RE: OSUNA COMMERCIAL SUBDIVISION DRAINAGE PLAN

I have made an initial review of the referenced project and forward the following comments:

L. B. NELSON CONDOMINIUM PROJECT

Re: L.B. NELSON - OSUNA PROJECT DRAINAGE REPORT

SWALE CAPACITIES:

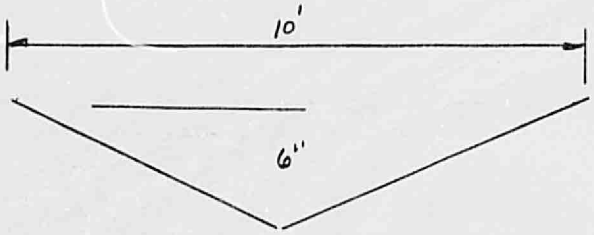
2. It's indicated that offsite flows of 6.1 cfs will be conveyed around the west side of the building. Does the proposed swale have sufficient capacity to convey the flow?

$S = 0.01$
$n = 0.02$
$A = 2.5\ SF$
$P = 10.05'$
$R_h = 0.25$

$$Q = \frac{1.49}{0.02}(2.5)(0.25)^{2/3}(0.01)^{1/2}$$

$$Q = 7.4\ CFS$$

$Q_{100\ MAX} = 6.1\ CFS < 7.4\ CFS$ OK ✓
